# UNITED STATES PATENT AND TRADEMARK OFFICE

10/574,234

<b>Office Action Summary</b>	<b>Application No.</b> 10/574,234	<b>Applicant(s)</b> ERIKSSON, BROR	
	<b>Examiner</b> Shelley Self	<b>Art Unit</b> 3725

## **DETAILED ACTION**

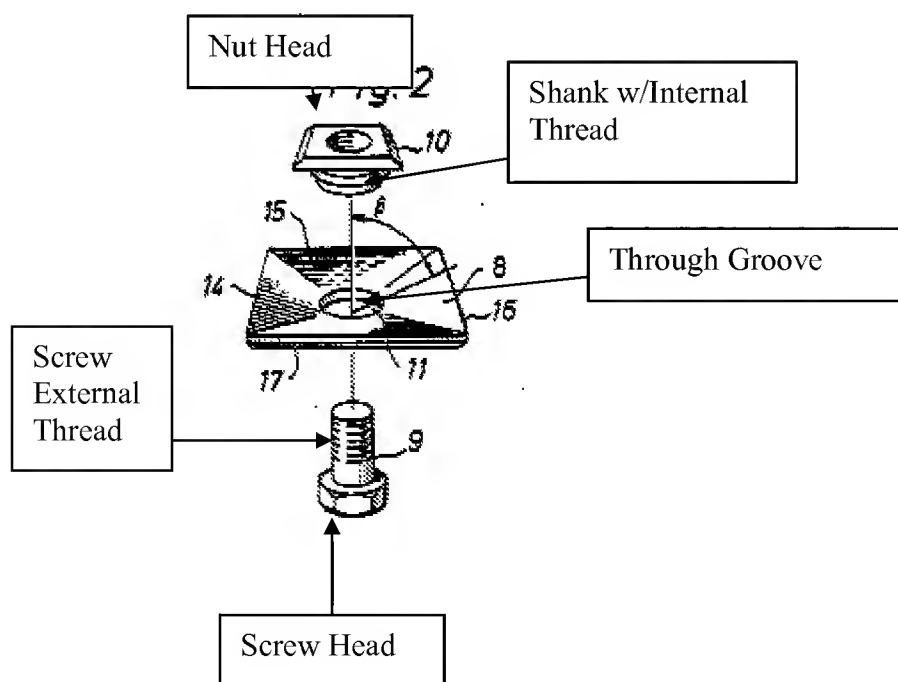
Claims 1-8 as best as can be understood are rejected under 35 U.S.C. 102(b) as being anticipated by Jonsson (4,231,046). With regard to claims 1 and 6, Jonsson discloses a barking device comprising a barking arm (fig. 1), a barking tool (8), which has at least one barking edge (fig. 3), which is mountable in a tool seat (fig. 3) at an outer end of the arm (fig. 1), the barking arm being pivotally connectible to a rotor, the barking tool comprising a convex mounting surface (fig. 3) to abut against a concave seat surface (12; fig. 3), connecting means mountable to the tool seat, characterized in that the connecting means comprises two connecting means parts, a first connecting means part in the form of a screw (9) with an externally threaded shank (fig. 2) and a head (fig. 2) and a second connecting means in the form a "sleeve-like nut" (10) with an internally threaded shank (fig. 1) into which the shank of the screw (9) is screwable and a head, the barking device further comprises a through hole (fig. 1-3) and through groove, a counter sink (fig. 2, 3) and mounting surface (fig. 23)

As to the recitation, “sleeve-like nut with internal threaded shank”, Examiner notes Jonsson, inherently disclose the sleeve (10) to be internally threaded so as to securing fasten the screw (9) to the device for securing the barking tool (fig. 3).

With regard to claim 2, Jonsson discloses wherein the length of the shank (fig. 2) of the nut (10) is adapted so that, when the nut is in the connecting position the nut extends at least a distance into the part.

With regard to claim 4, as best as can be understood, Jonsson discloses a groove shaped concave seat (fig. 3).

With regard to claims 5 and 8, as best as can be understood, Jonsson discloses a ridge extending essentially perpendicular to the intended direction of feeding of the logs (fig. 1-3)
